STAFF REPORT

Re: Vista 600 West Phase 2 Building A — Site Plan Amendment Request

Application No.: 2023-0293-SP
Applicant: Eric Winters, representing Wasatch Residential Group
Project Location: Approximately 13645 S. 600 West
Current Zoning: TSD (Transit Station Development) Zone
Acreage: Approximately 6.98 acres (304,048 square feet)
Request: Request for approval of a Site Plan Amendment application in the TSD zone for the reconfiguration of a retail building pad.

OVERALL SITE PLAN

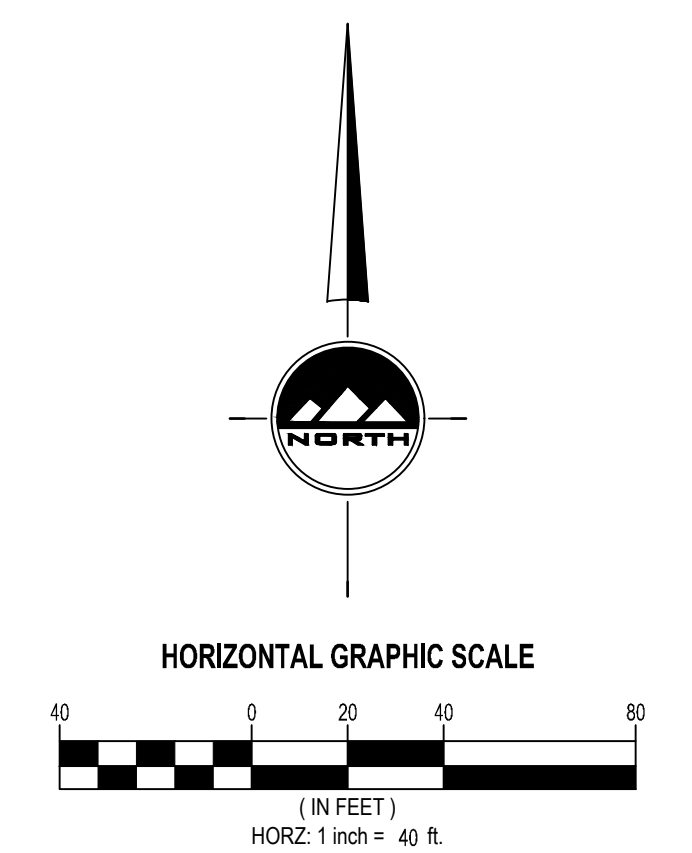
Site Plan Layout. The approved site plan shows the two residential buildings, three retail buildings and the hotel. The applicant has a client who desired to have more parking for their business and a smaller building (Exhibit F). Building A will be reduced in almost half and 14 parking stalls added. The building will continue to have a drive thru which meets all requirements for stacking and queuing. The building continues to meet all applicable setbacks for the MAP.

Parking. The applicant has provided a total of 432 parking stalls for the entire project (Exhibit F). This is an increase of 14 parking stalls from the prior approval. The increase in parking stalls is acceptable to staff as there is no maximum parking requirement in the TSD zone. The proposed retail component meets the minimum standard but the proposed and potential uses are not all retail uses and may generate additional traffic and the need for additional parking. A shared perpetual parking easement is also included on the subdivision plat and parking is intended to be shared among uses for the proposed development and the existing residential units.

1. RMP concrete pads are located with the clear view triangles located at access(es) and a points within the development where visibility is required. Verify the proposed electric equipment do not exceed three feet in height maximum. Power structures that exceed this height will be required to be relocated. (Relocate pads away from access a minimum of 15 feet (typical) to be located outside clear view triangle.)

EXHIBIT G
LANDSCAPE PLAN

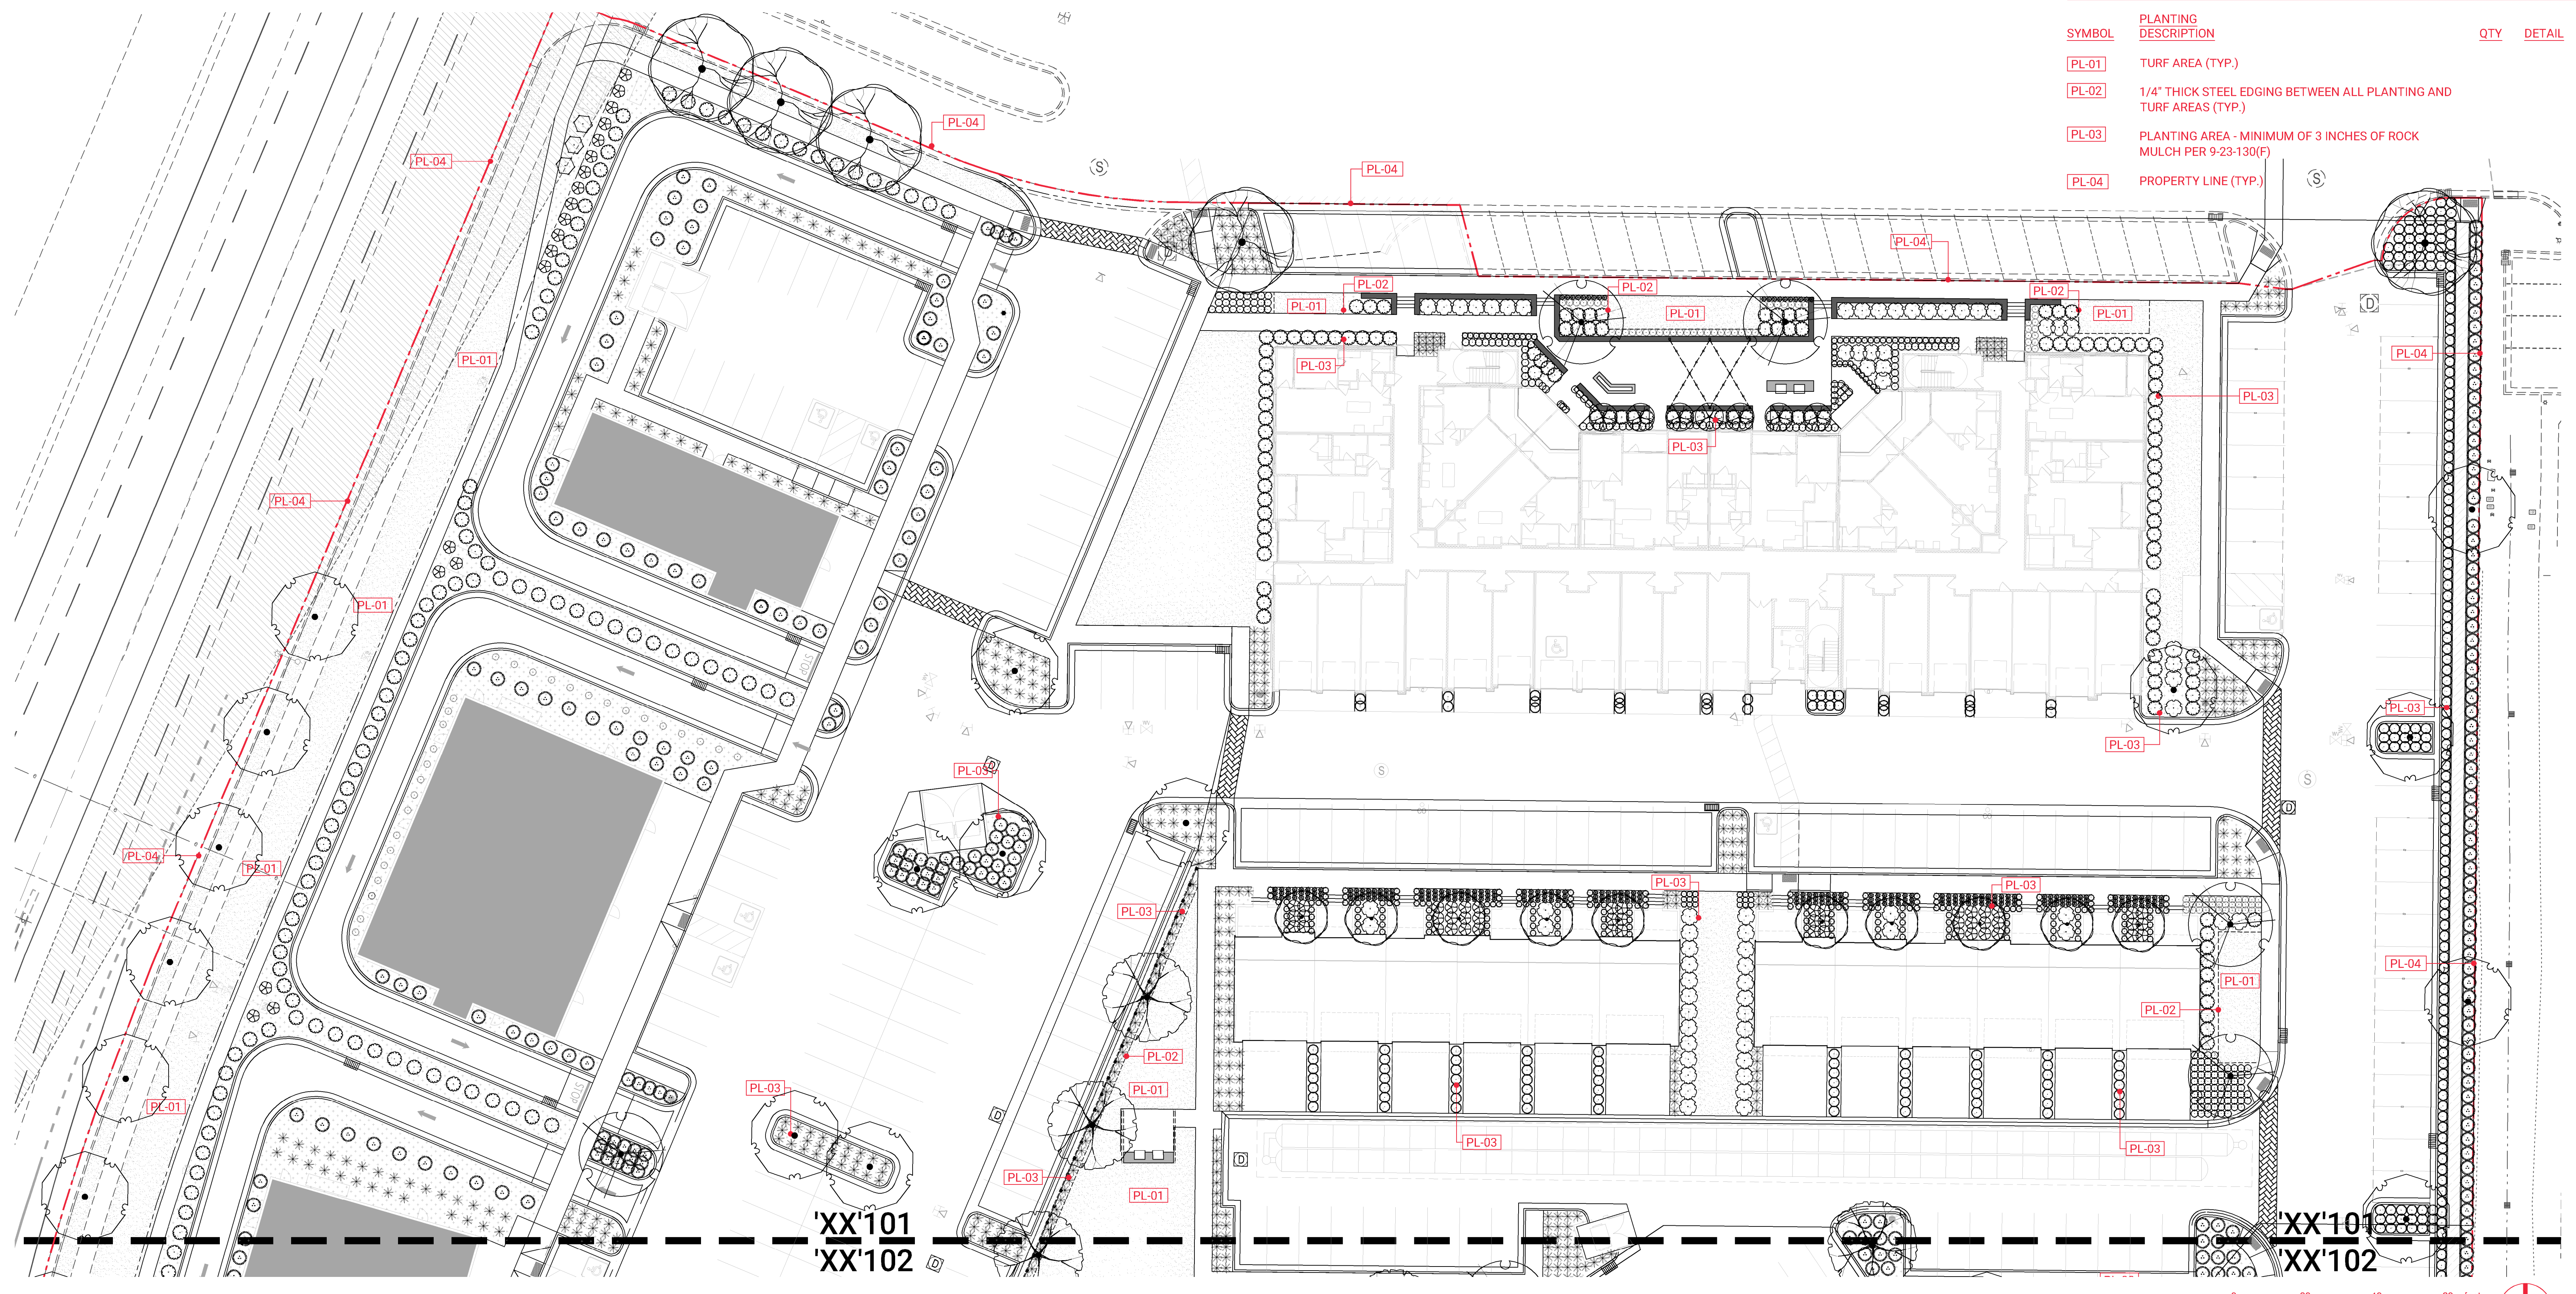
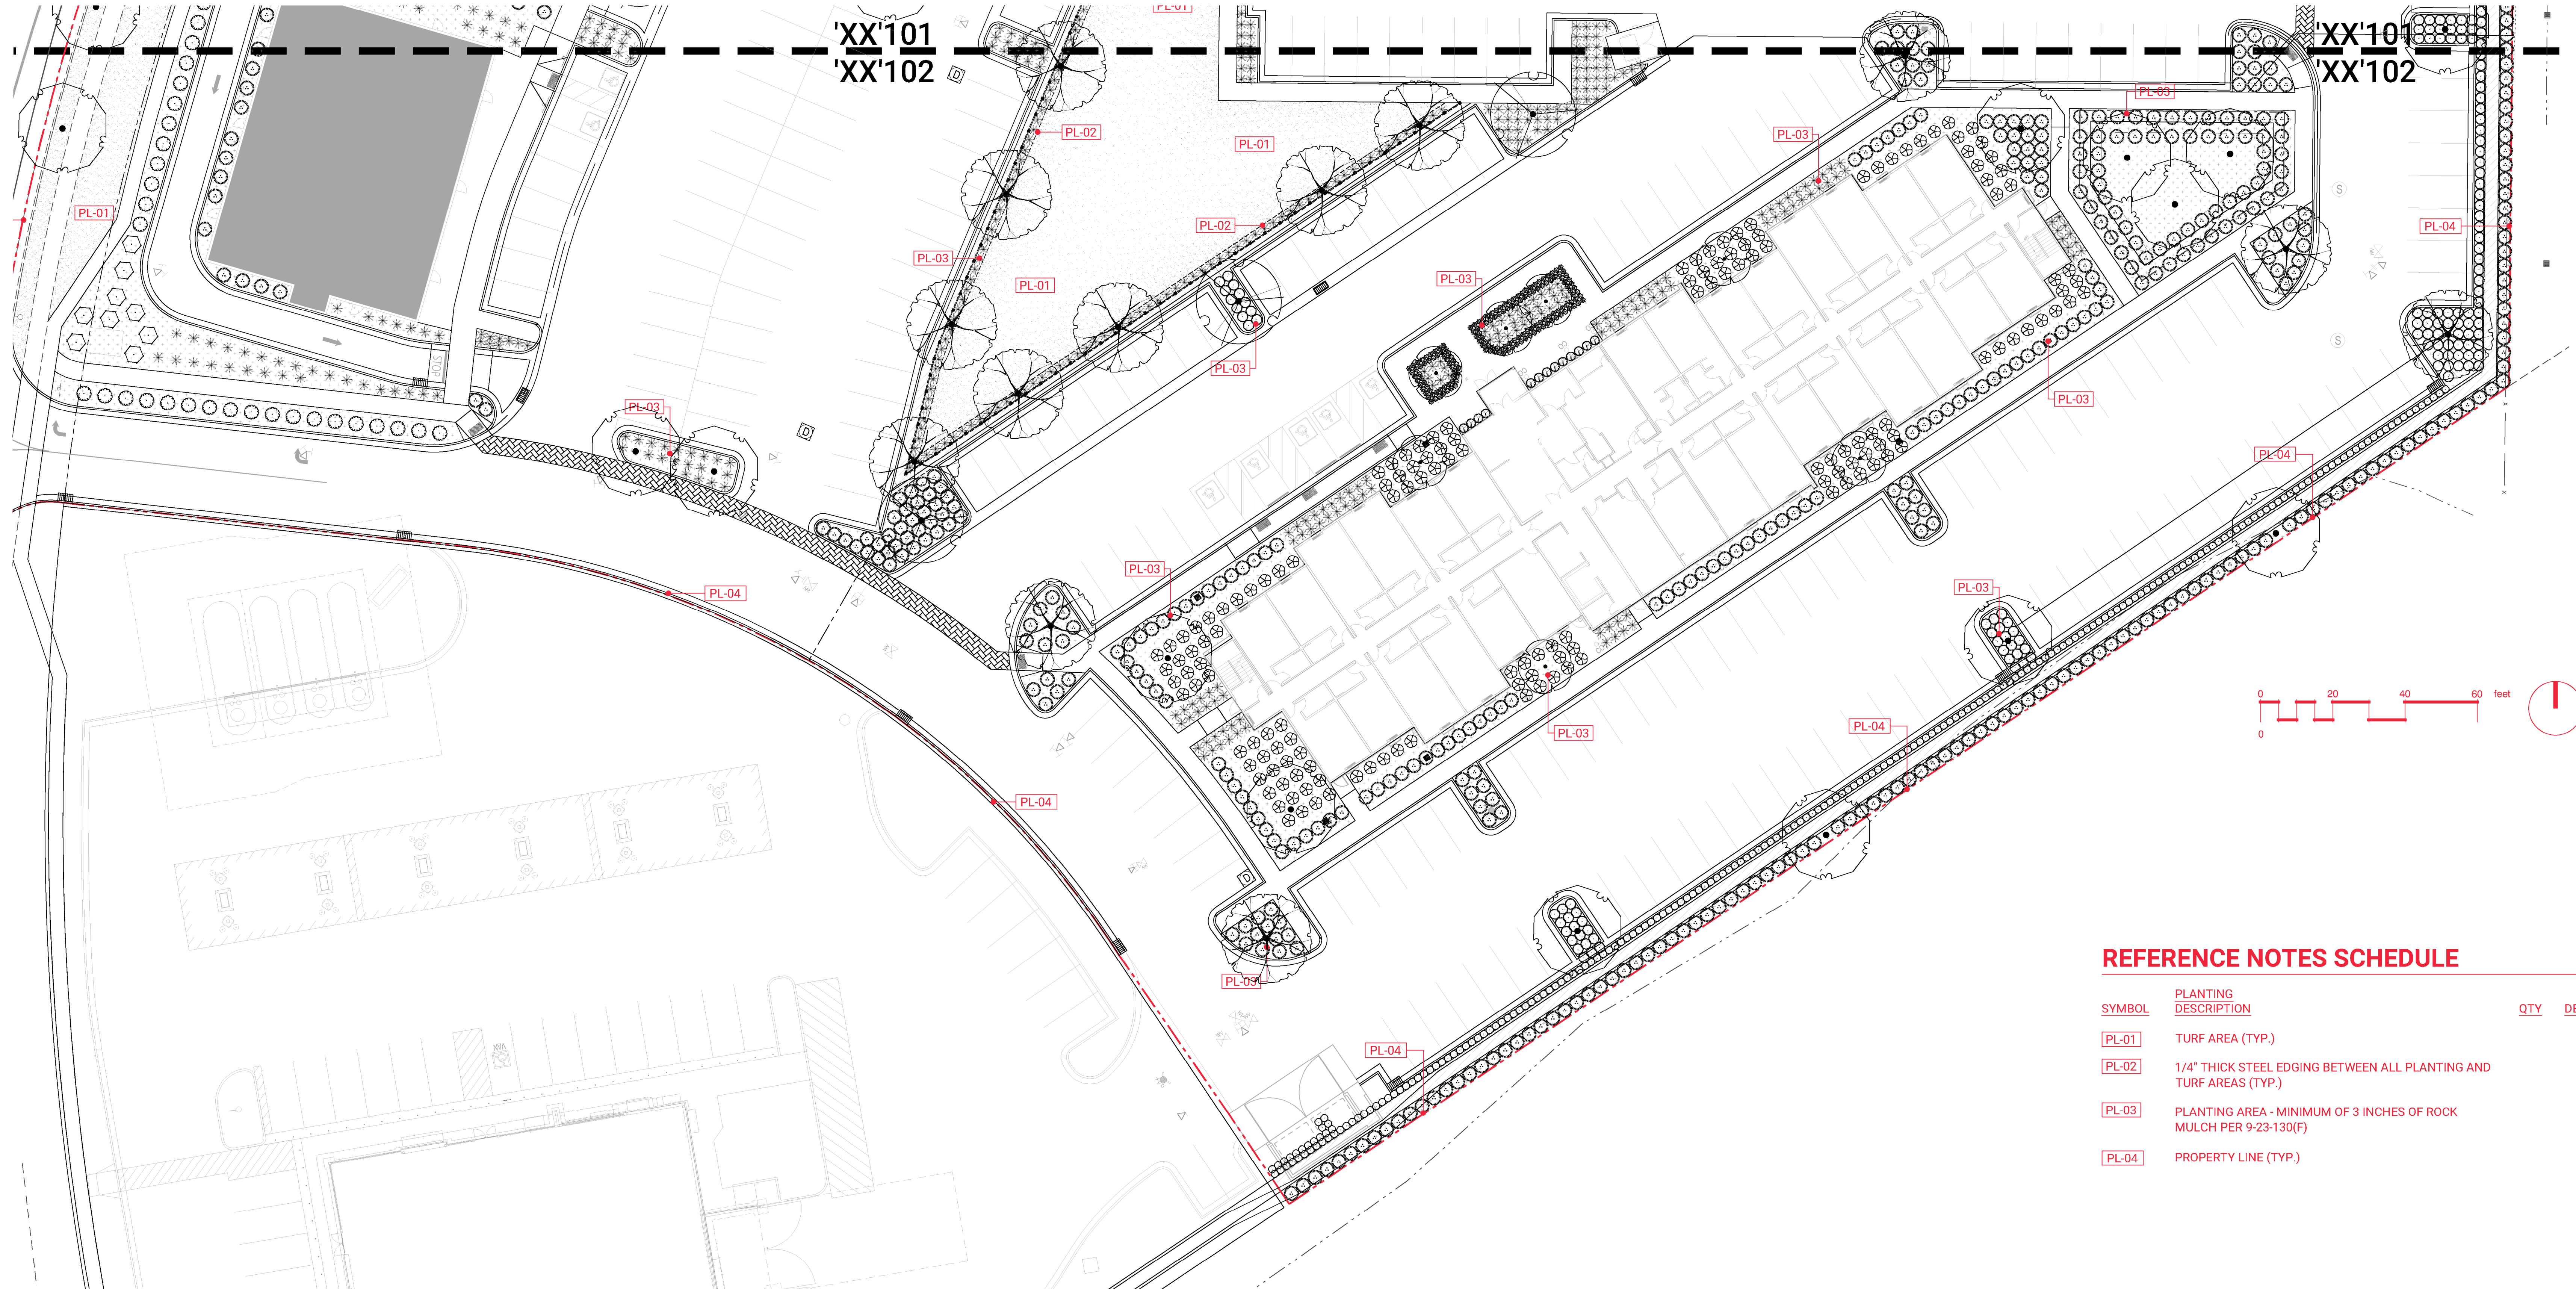
Landscaping and Lot Coverage. The applicant has provided a landscape plan which complies with the standards of the TSD zone and the MAP (Exhibit G). The landscape plan

continues to show defined entrances, landscaping throughout the project and a variety of tree, shrubs and groundcovers. Approximately 29.2% of the site area will be landscaped which is a slight increase of approximately 1% from the prior approval. All changes to the landscaping plan were to the area around the modified building and there were no changes to the rest of the site.
